ZH3 ASSY P/N :31ZH3MB0008
ZH3 MB C/S ASSY P/N: 41ZH3CS0001
ZH3 MB S/S ASSY P/N: 51ZH3SS0003

PROJECT :ZH3
Quanta Computer Inc.

Change list

SB-1

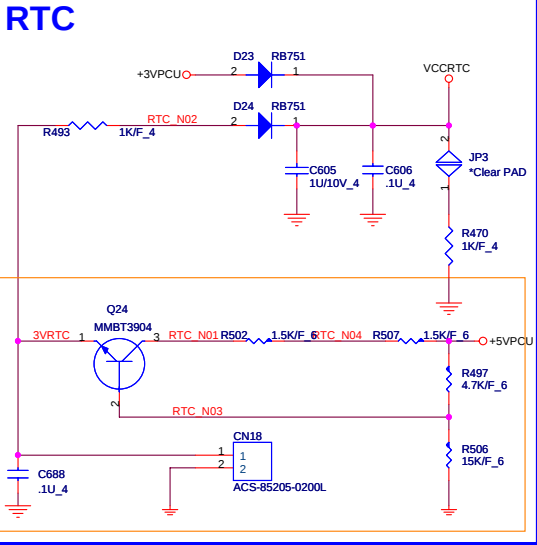
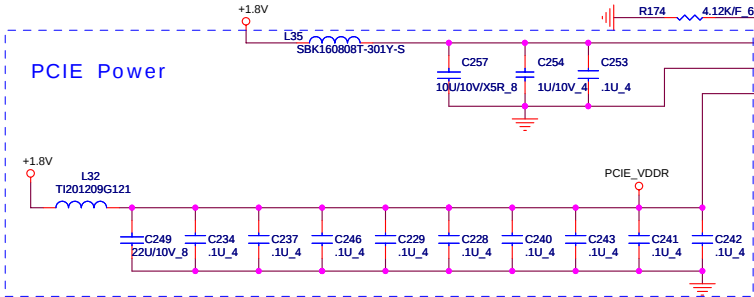
D3A: Due to remove bridge battery, Add RTC circuit ,

LAN BCM5788:
AD20 REQ2#
GNT2# INTG#

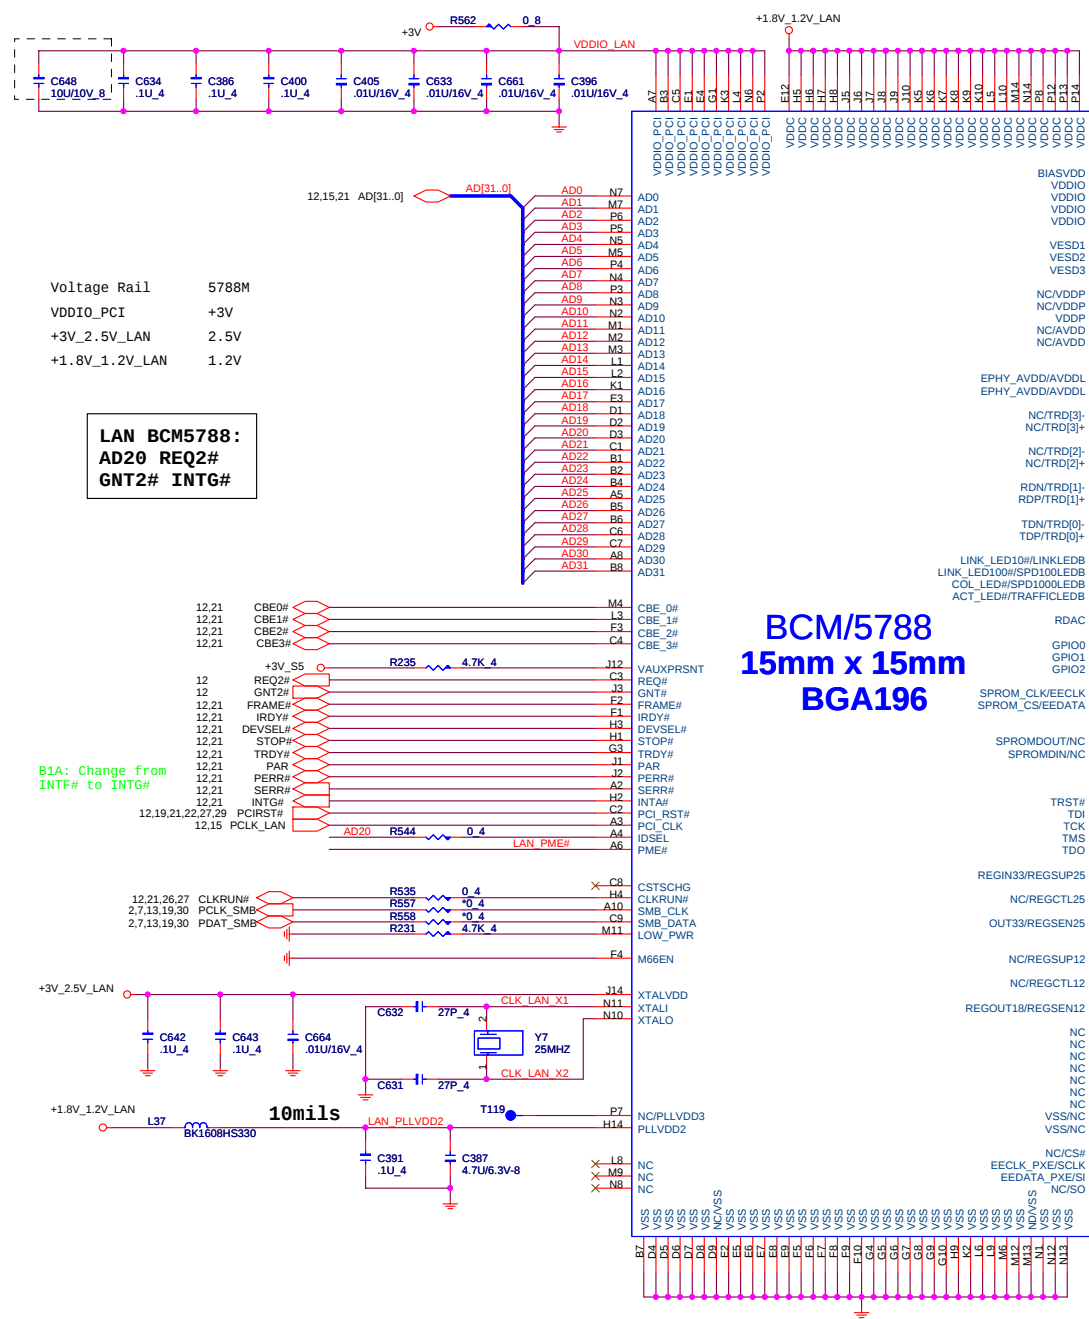
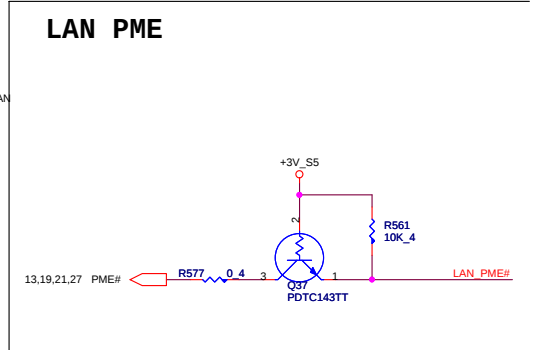
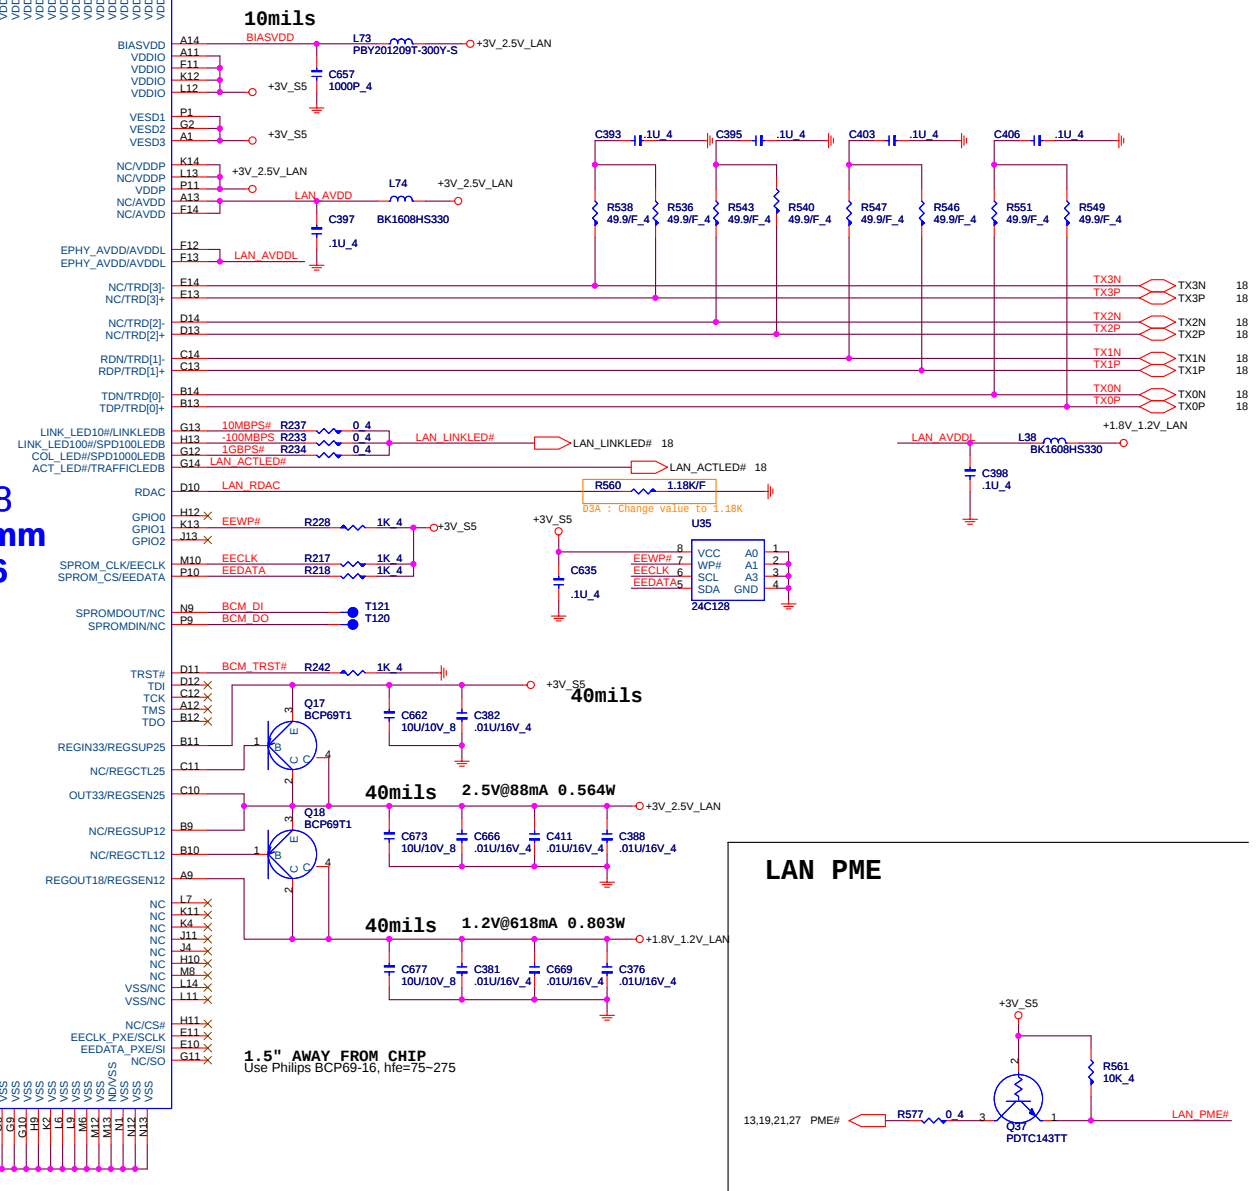
B1A: Change from
INTF# to INTG#

JSIM1

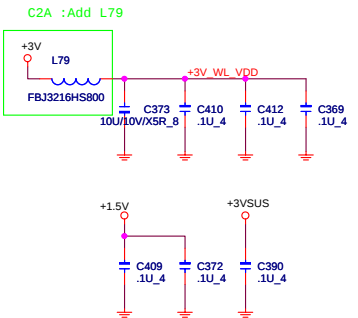
B1A:These signals of reserve have be used by wireless module of Foxconn BG. These signals impact LPC. I remove signal line in order to solve the WLAN issue.

B1A: Change footprint
C2A: Change footprint & modify SIM card PIN define

Size Custom Document Number SIO (87383) & FIR Rev D
Date: Thursday, June 29, 2006 Sheet 26 of 36

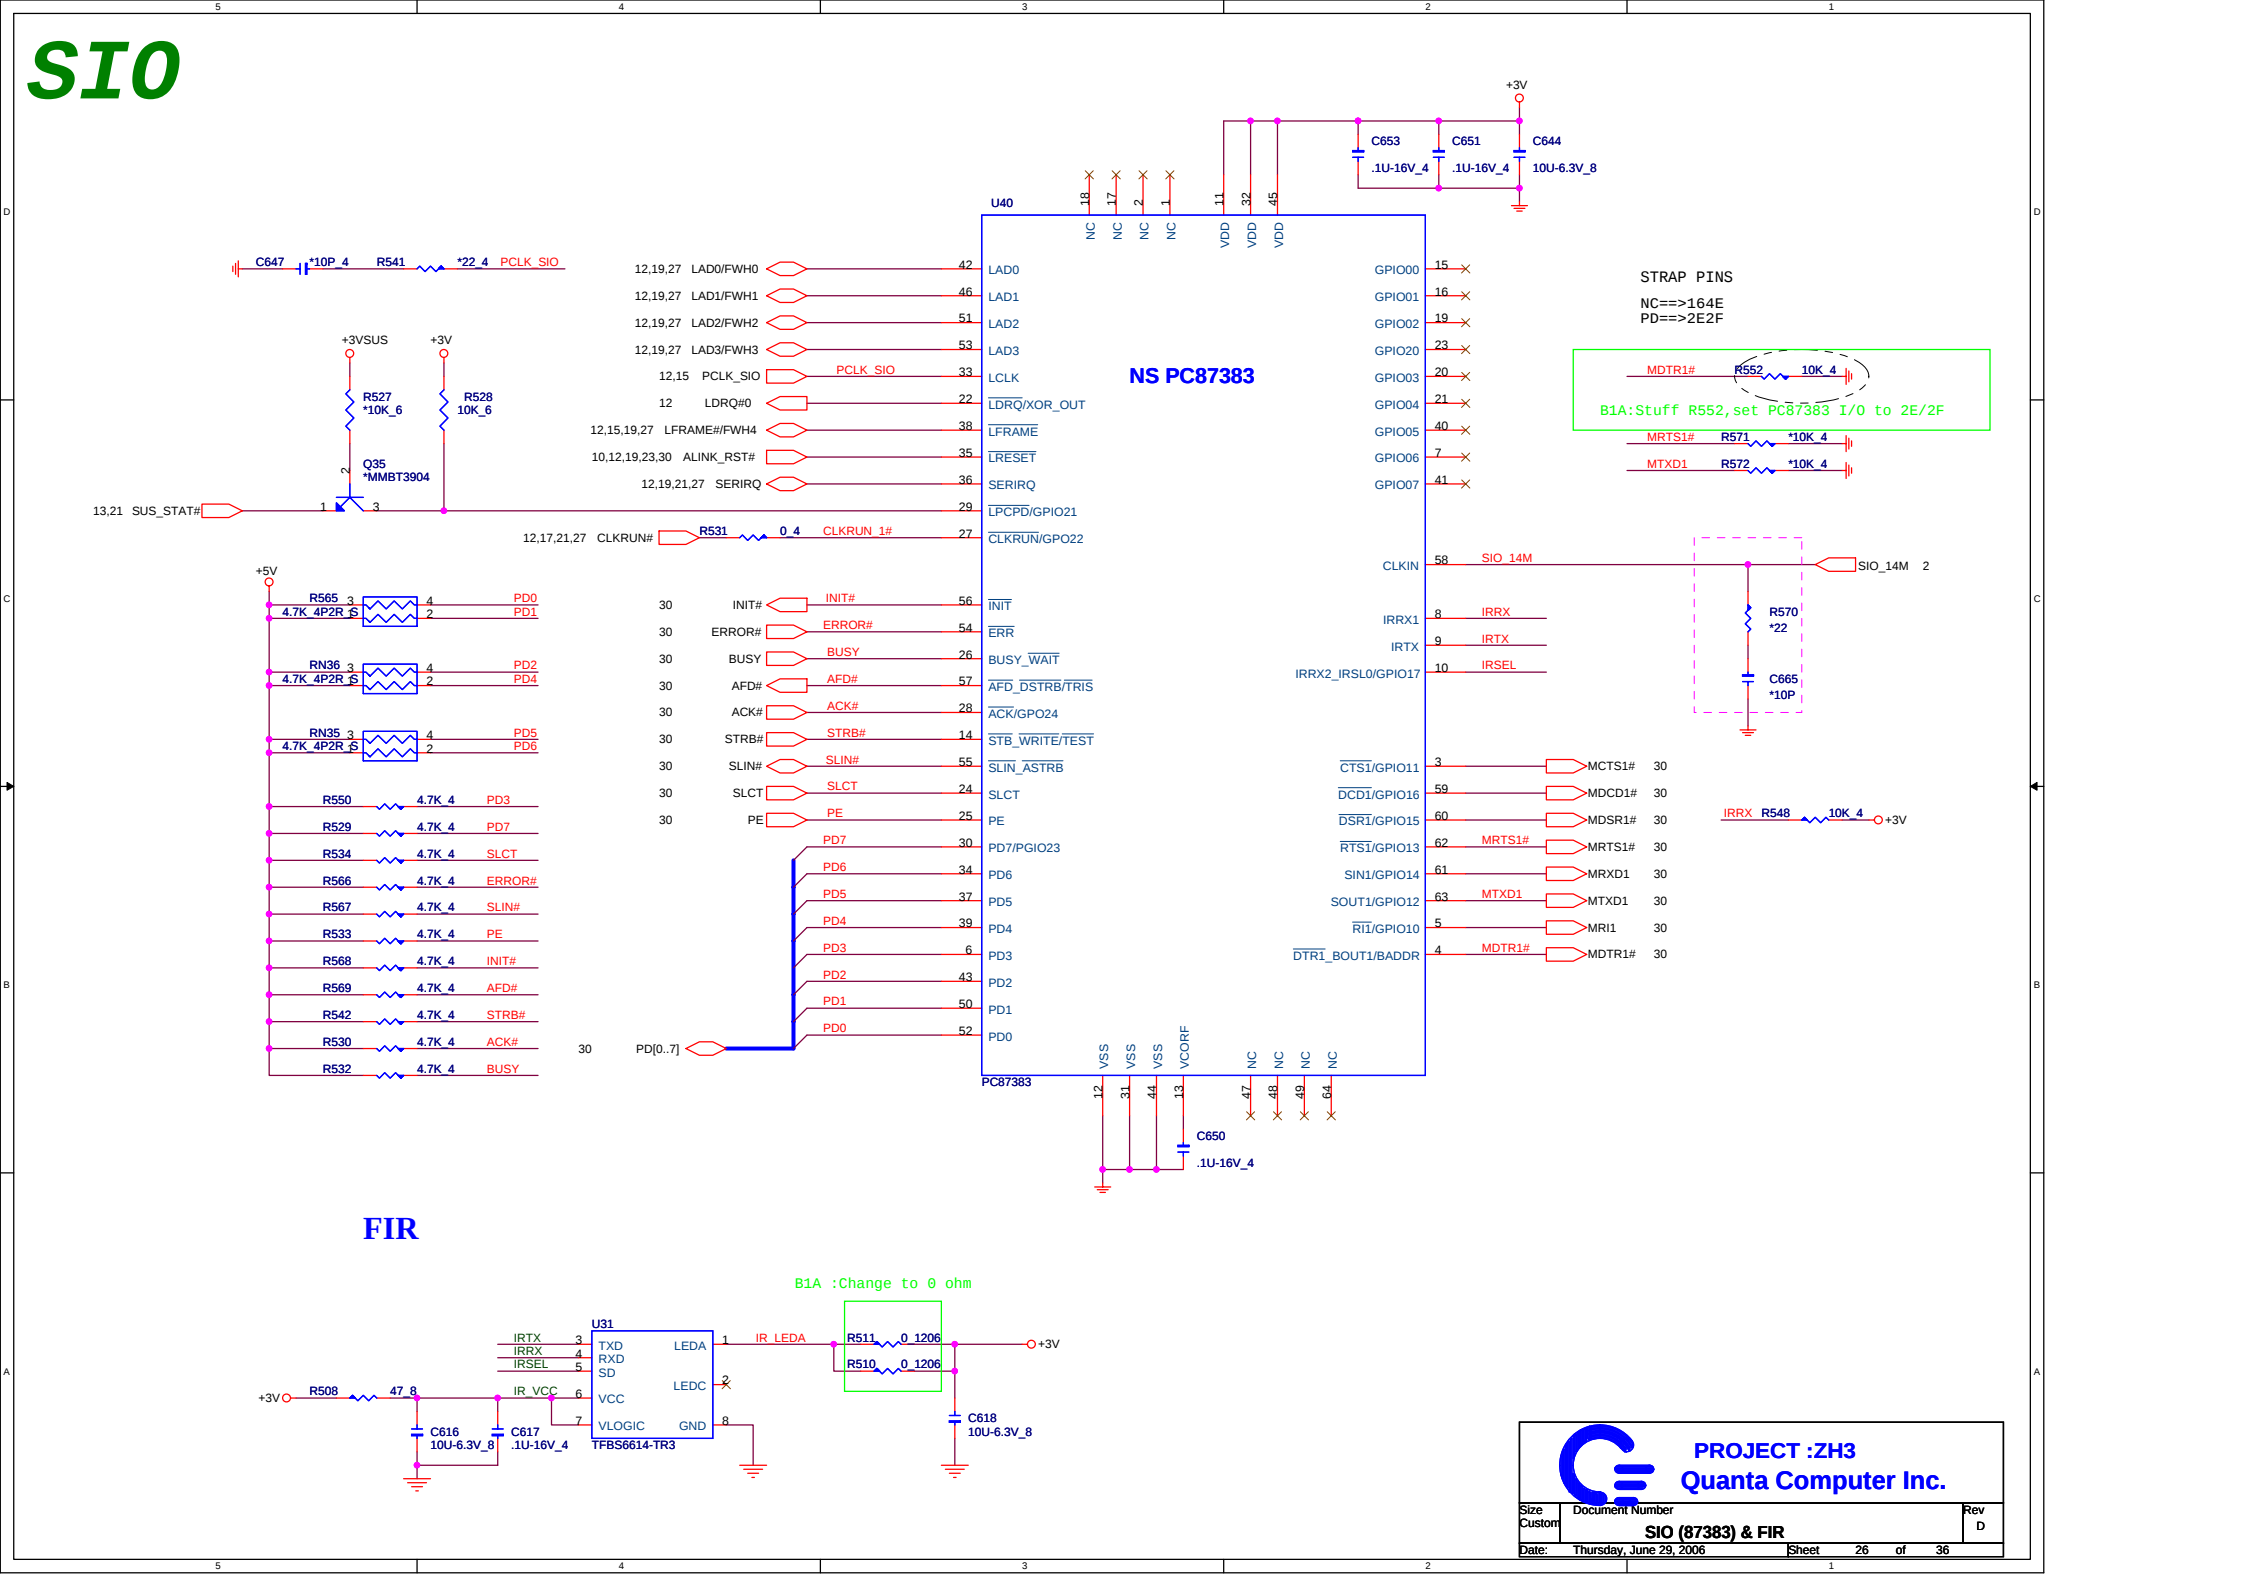
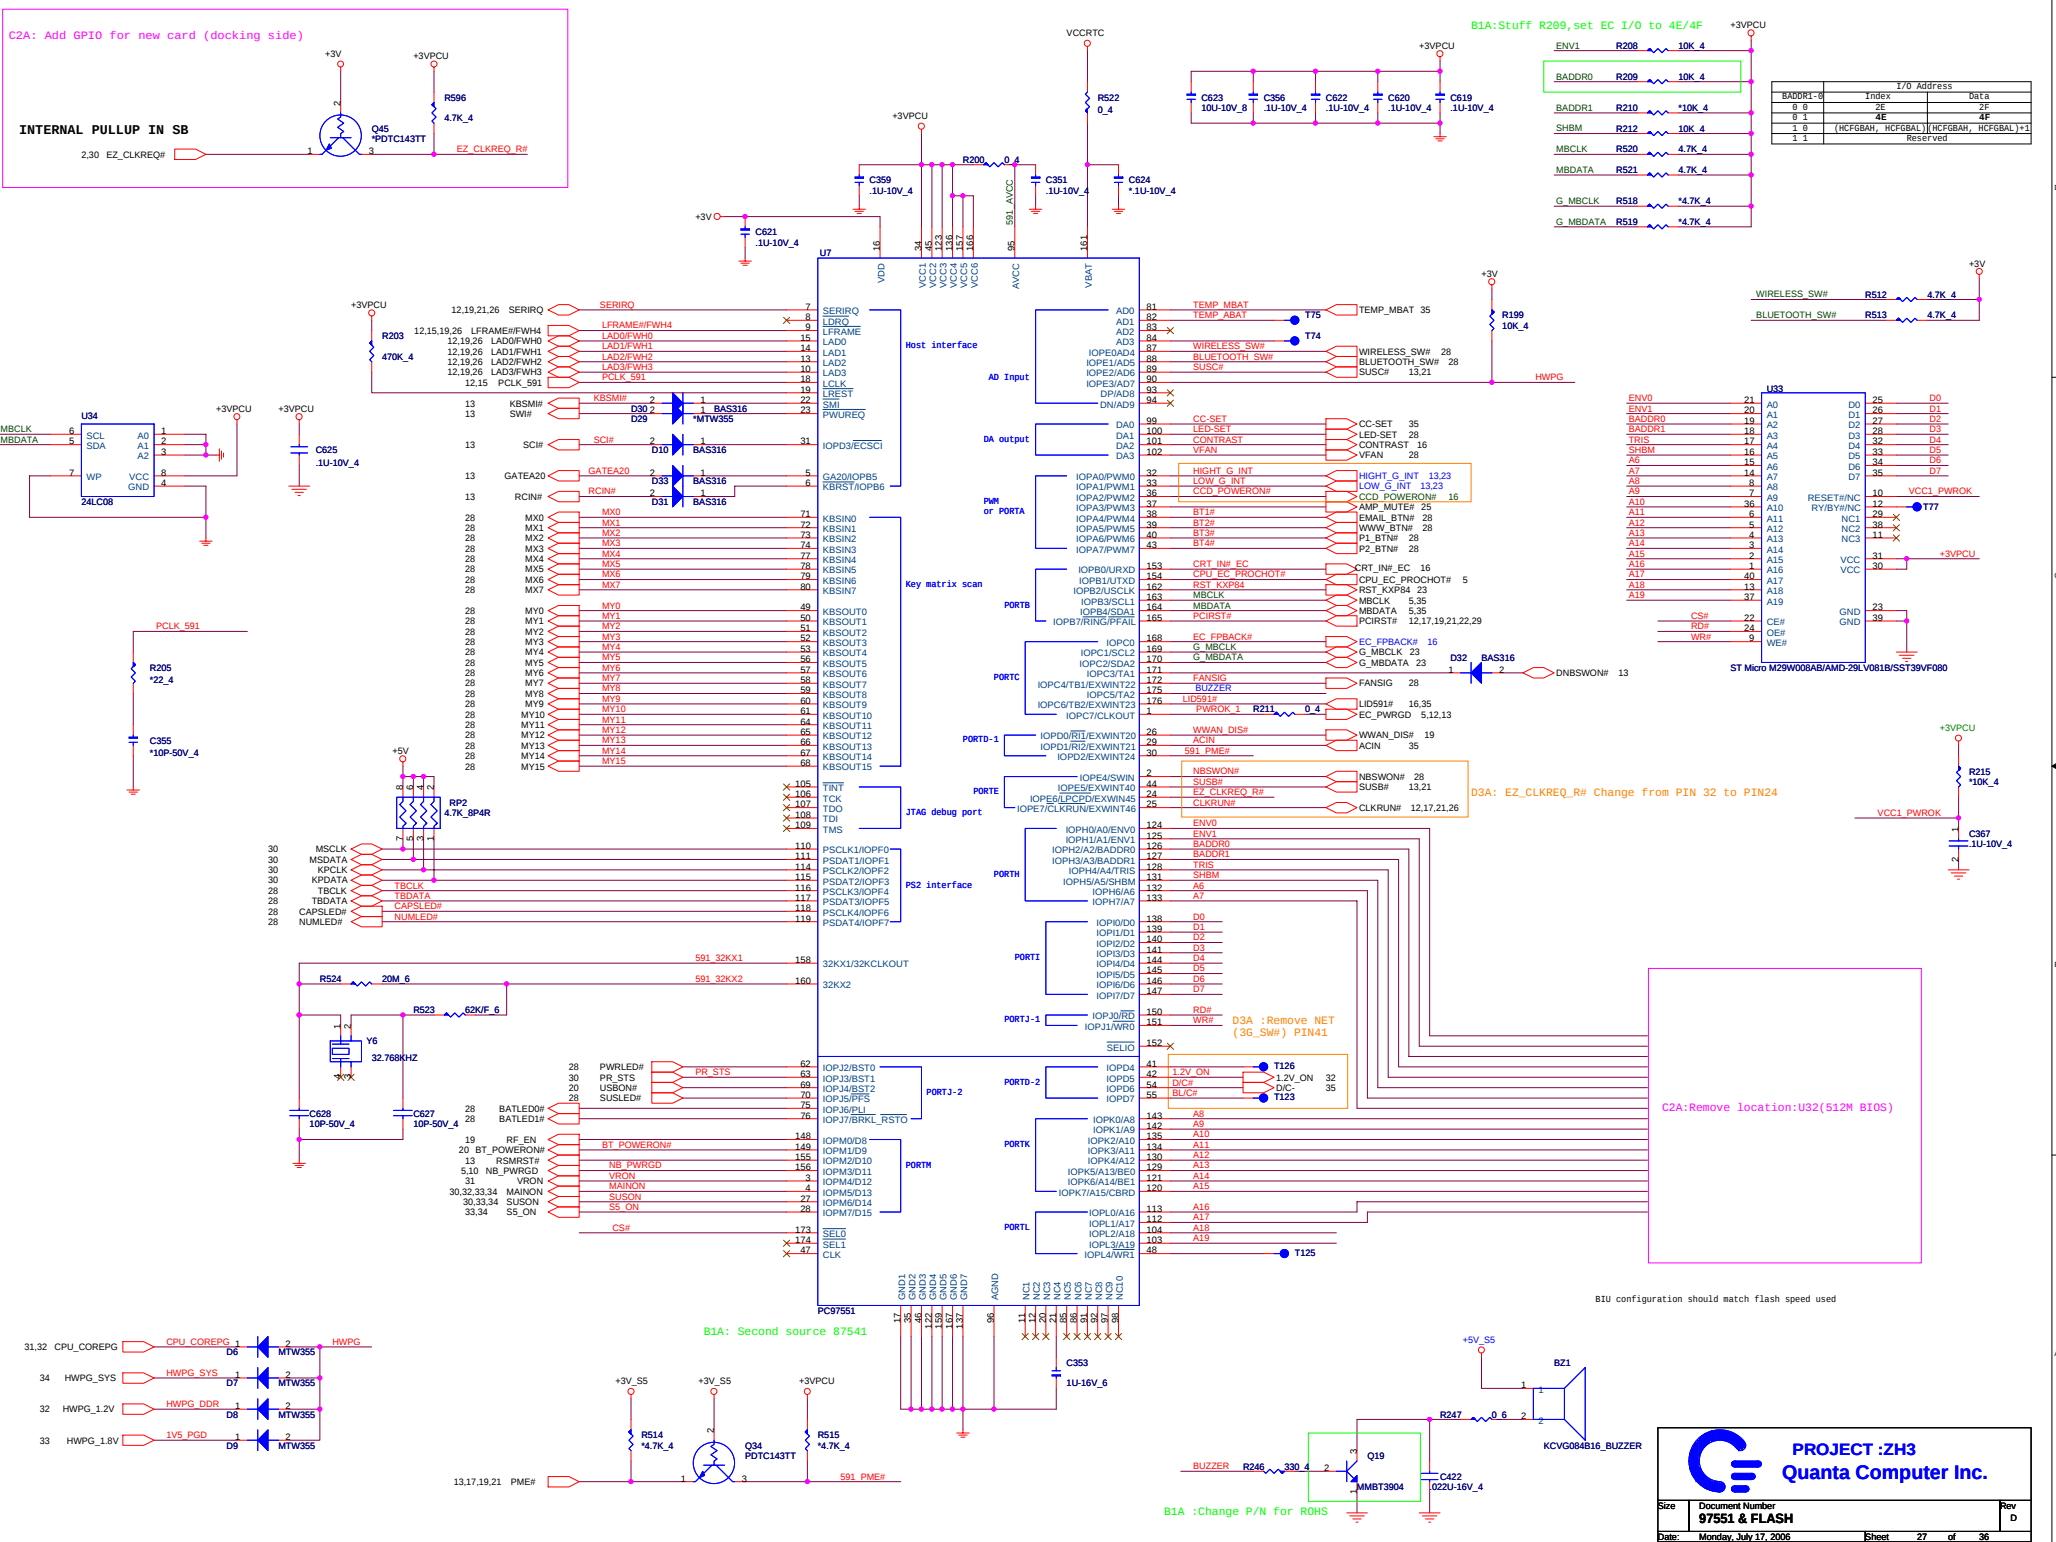
B1A: Stuff R552, set PC87383 I/O to 2E/2F

B1A :Change to 0 ohm
